1970 - 1973 Corvette: Service Bulletin: Engine Overheat

Subject: Engine Overheat

Model and Year: 1970 - 1973 Corvettes with 454 Cu. In. Engines and Air Conditioning

Bulletin Number: 73-T-28, Section VI

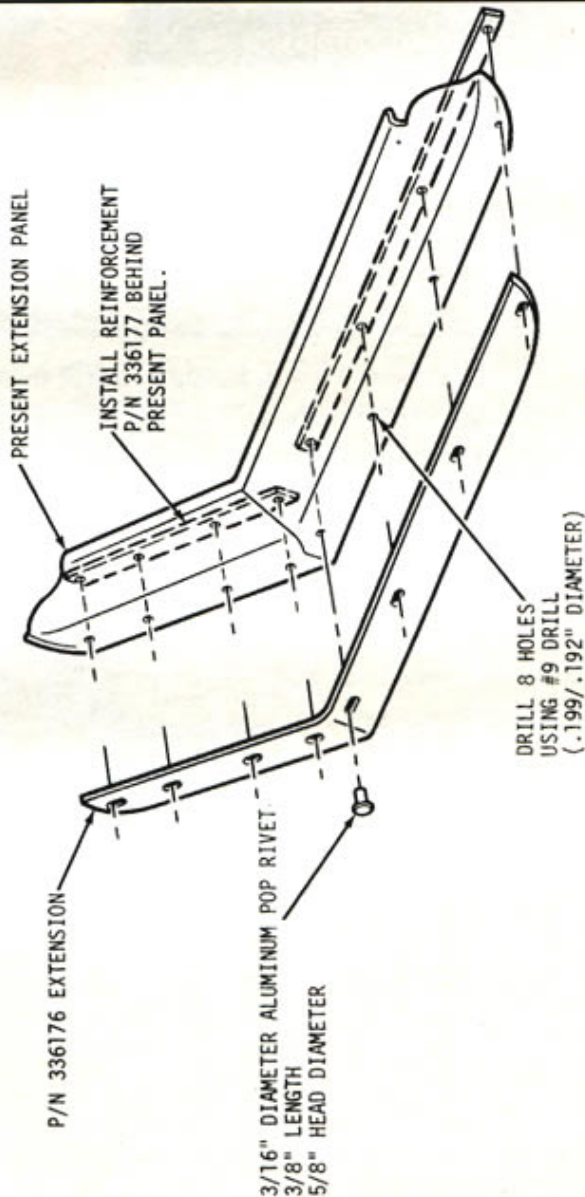
To improve low speed cooling, an additional grille panel lower extension was installed in 1973 Corvettes produced after Vehicle Identification Number 1Z37Z3S410722. This extension, Part Number 336176, may be installed as illustrated on page 2 of this bulletin on early 1973 Corvettes only .
